SR 3/US 41/Northside Parkway/ Cobb Parkway

**Project Number: BHFST-0001-05 (024), P.I. No.: 720125
and CSSTP-0009-00 (410), P.I. No.: 0009410
Fulton/Cobb Counties**

Value Engineering Study Report

August 2009

DESCRIPTION: **IN PHASE I, USE A SOIL NAIL WALL FOR WALL NO. 4 IN LIEU OF A MECHANICALLY STABILIZED EMBANKMENT WALL** SHEET NO.: **1 of 9**

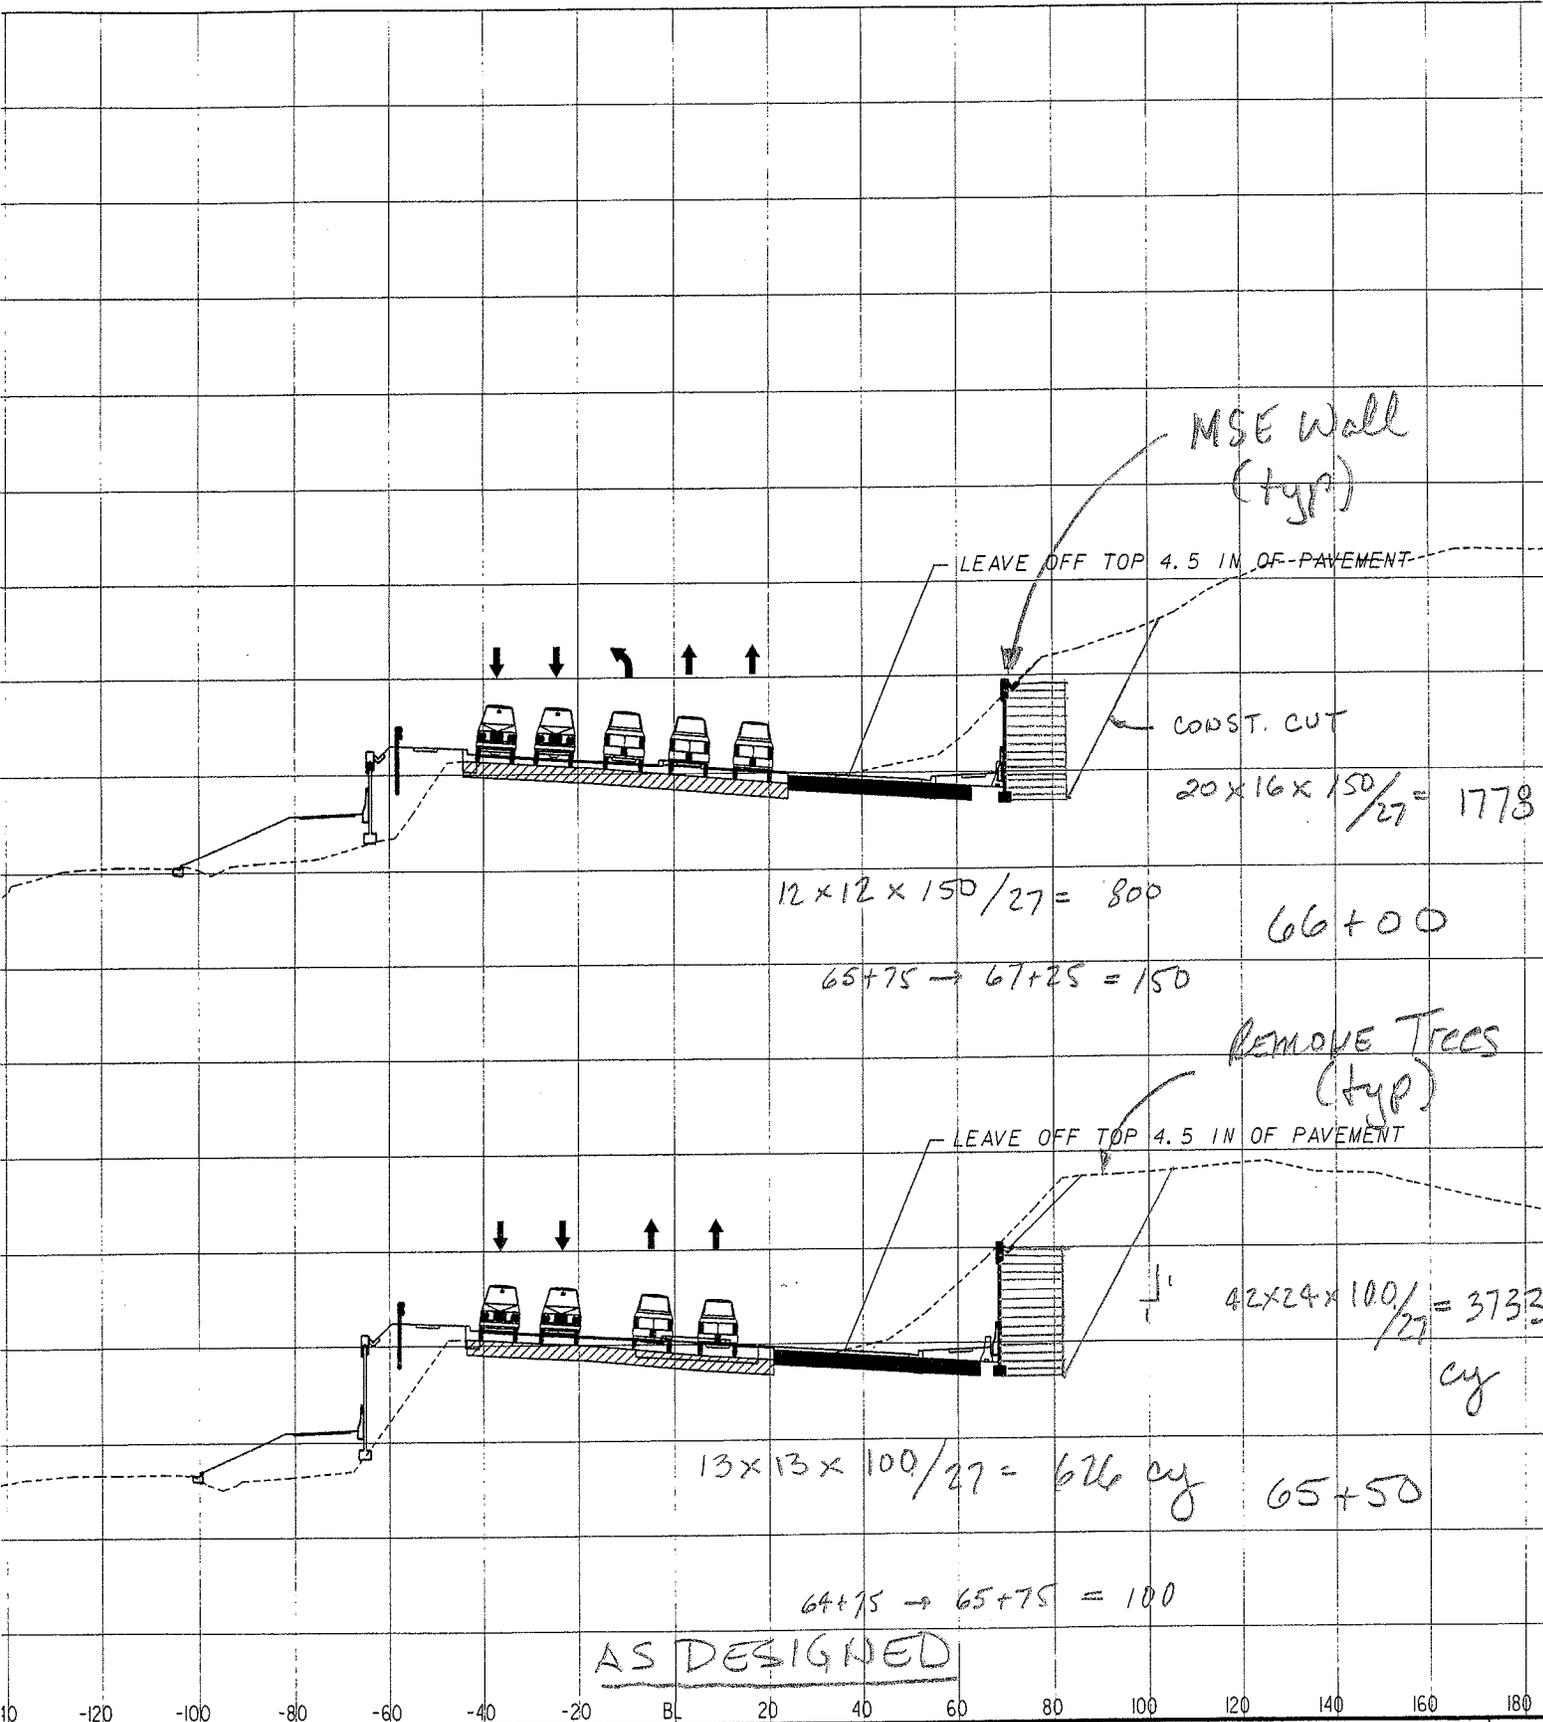
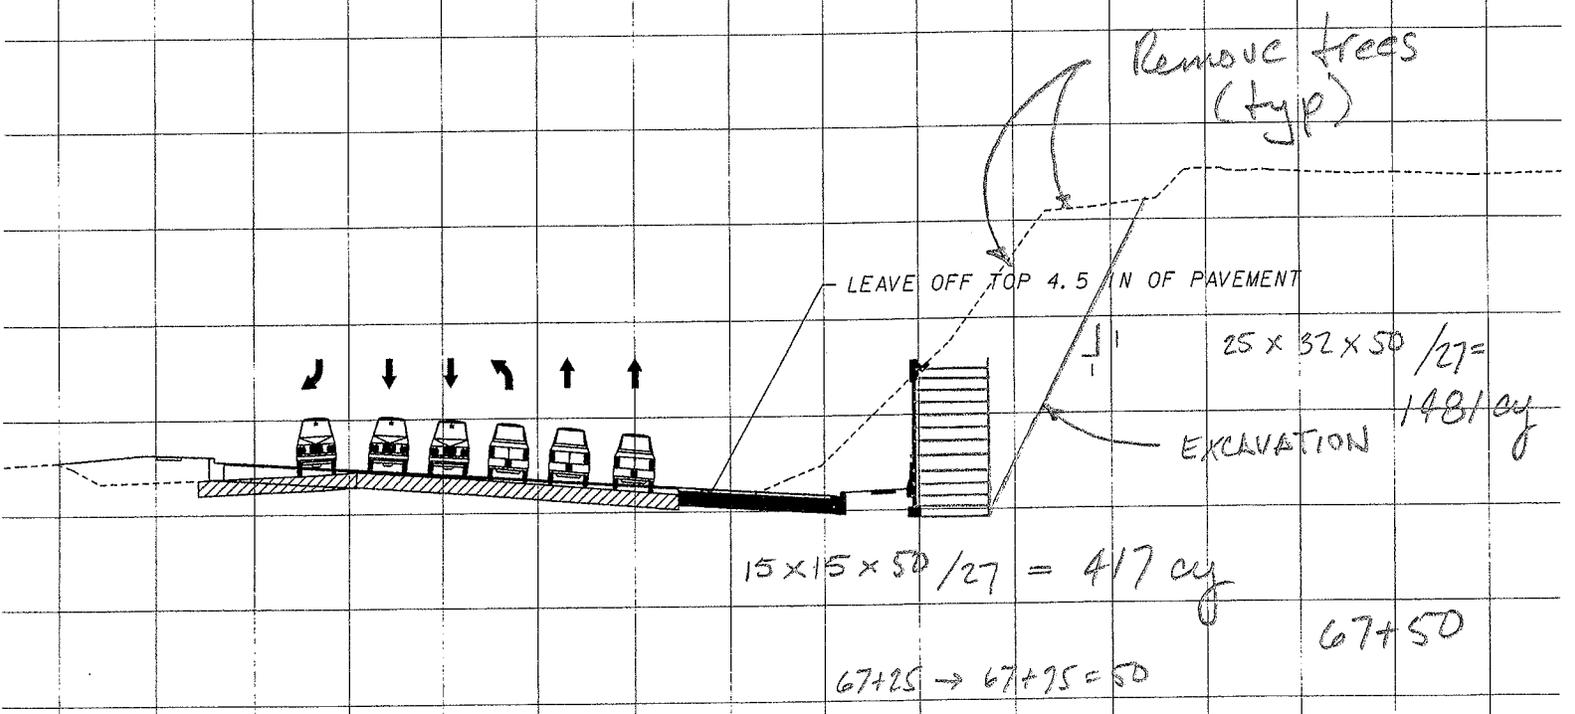
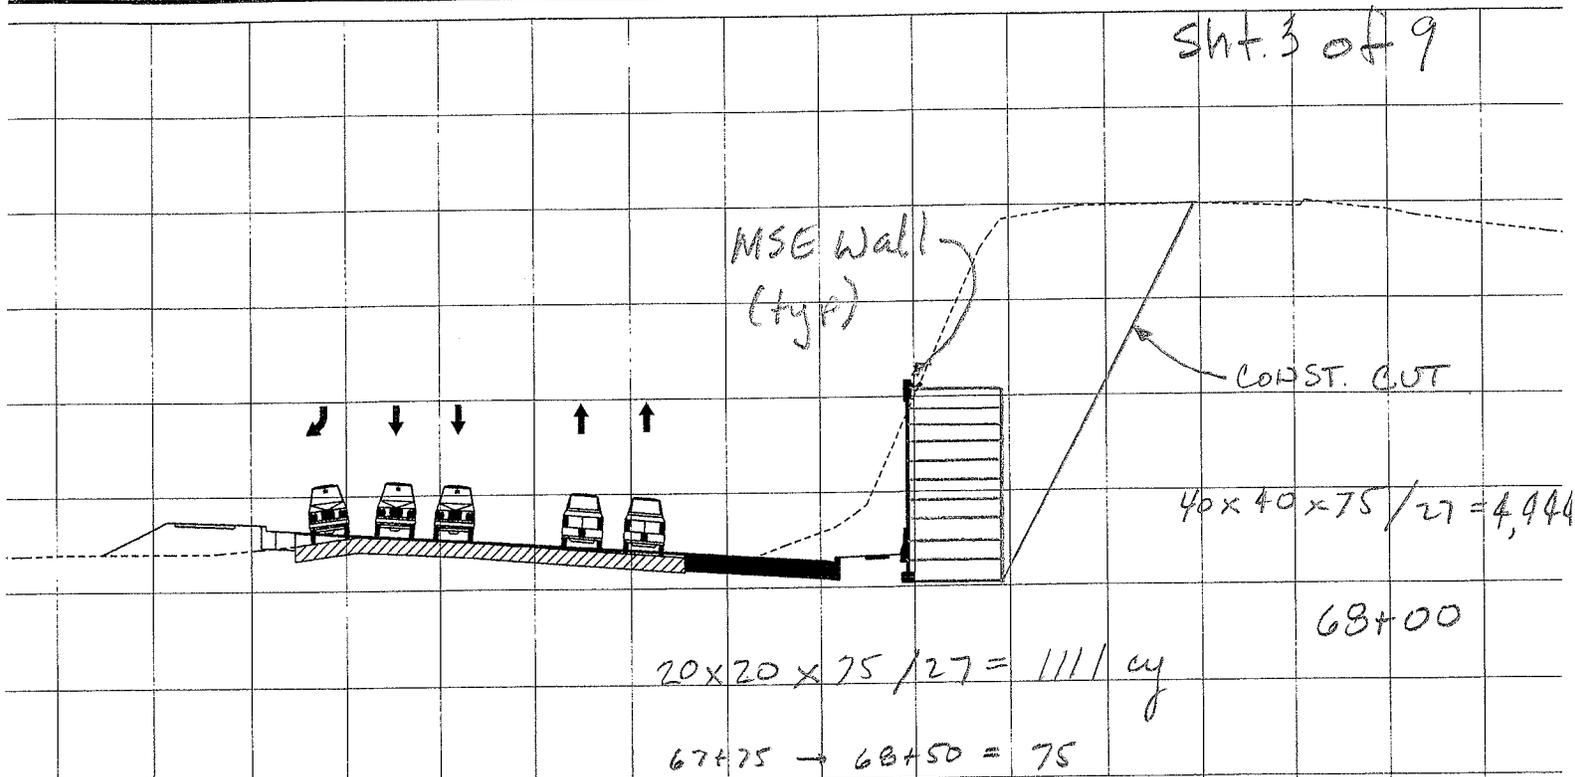
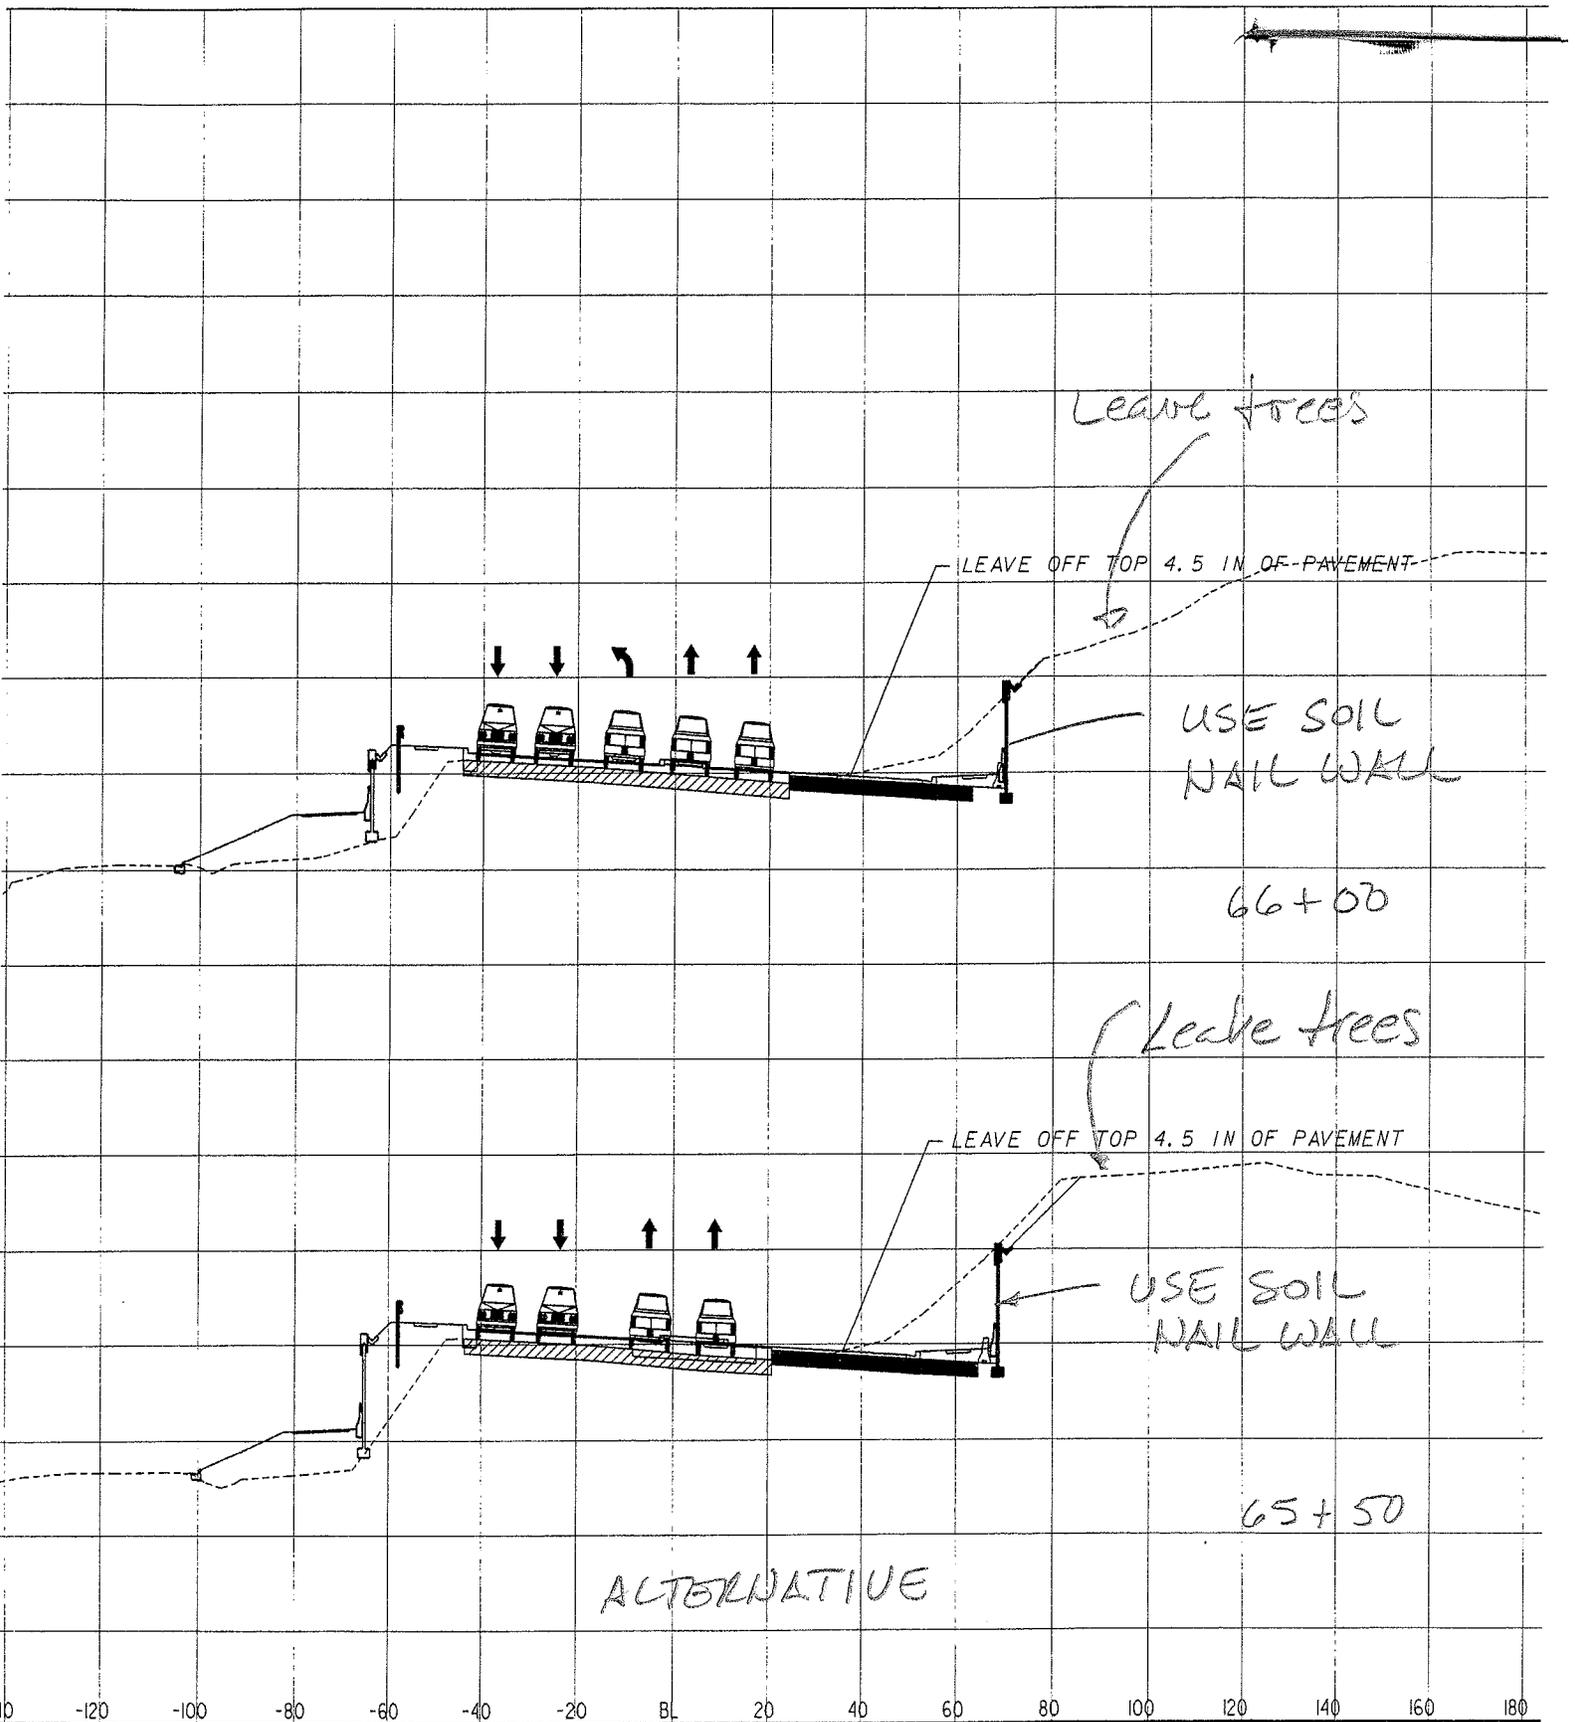
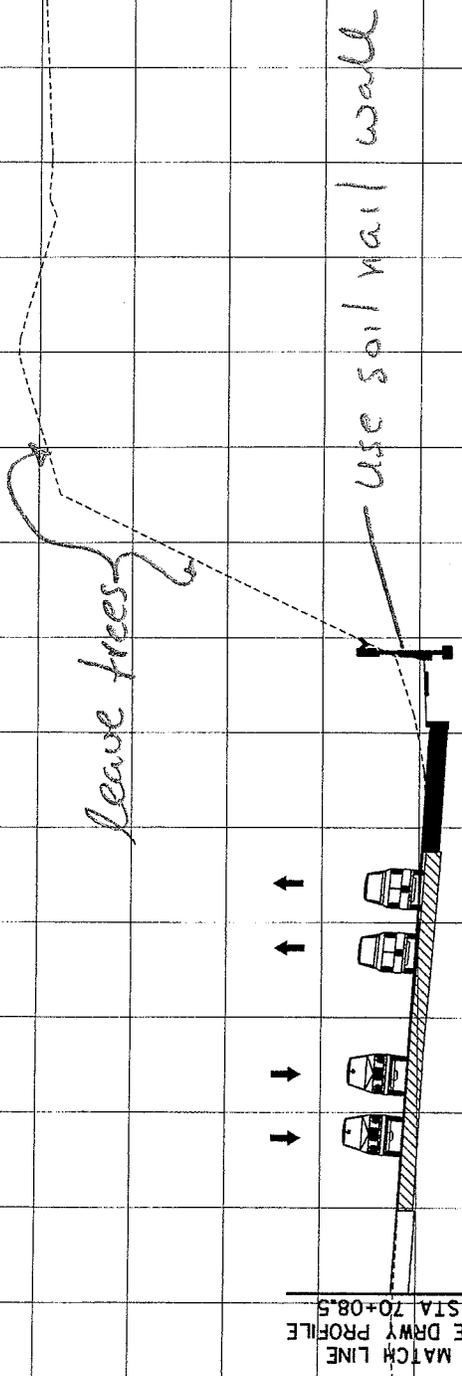
Remove trees
(typ)

leave trees

use soil nail wall
